| Title - Sujet Réfection de la place publique OACI | |
| Solicitation No. - N° de l'invitation EE520-192456/A | Amendment No. - N° modif. 005 |

Public Place Refection – ICAO House
Montreal (Qc)

AMENDMENT 005

IMAGE 1

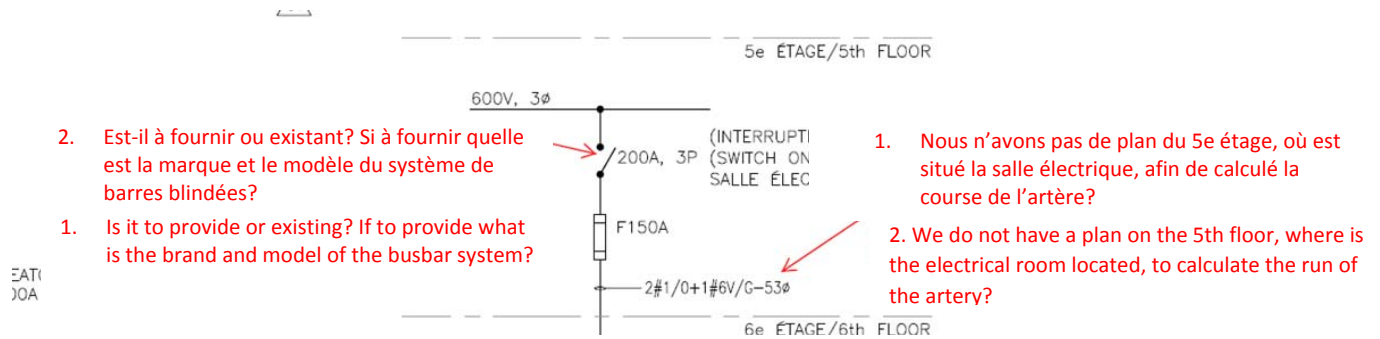
1. Is it to provide or existing? If to provide what is the brand and model of the busbar system?
2. We do not have a plan on the 5th floor, where is the electrical room located, to calculate the run of the artery?

1. The fuse switch is to be supplied and installed on existing enclosed bus bars. The enclosed bus bar model is Cutler-Hammer POW-R-WAY 1, 2 or 3.
2. The electrical room on the 5th floor is directly located under the 6th Floor electrical room.
3. The digital display panel is located outside on the facade of the building on the side of Boulevard Robert-Bourassa. The power supply comes from the electrical room on the 6th floor and the conduit run is carried out through the mechanical room to the outside.
4. The details of the location of the run and the piercing are to be coordinated on site with the owner.

IMAGE 2

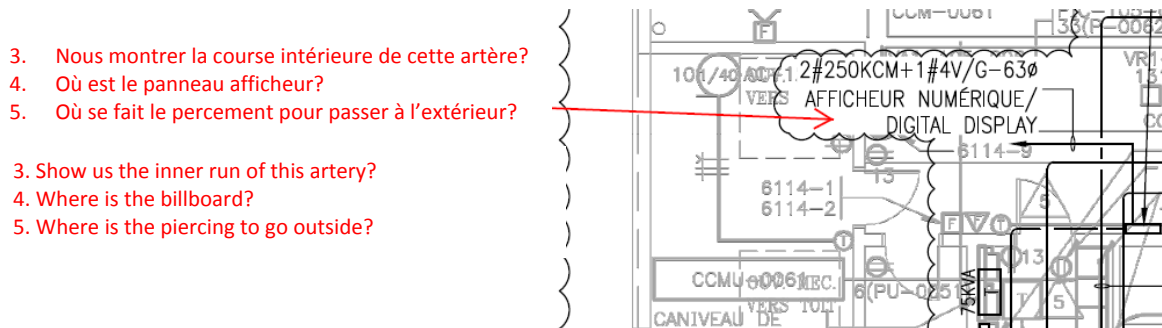
3. Show us the inner run of this artery?
4. Where is the display panel? Where is the piercing to go outside?
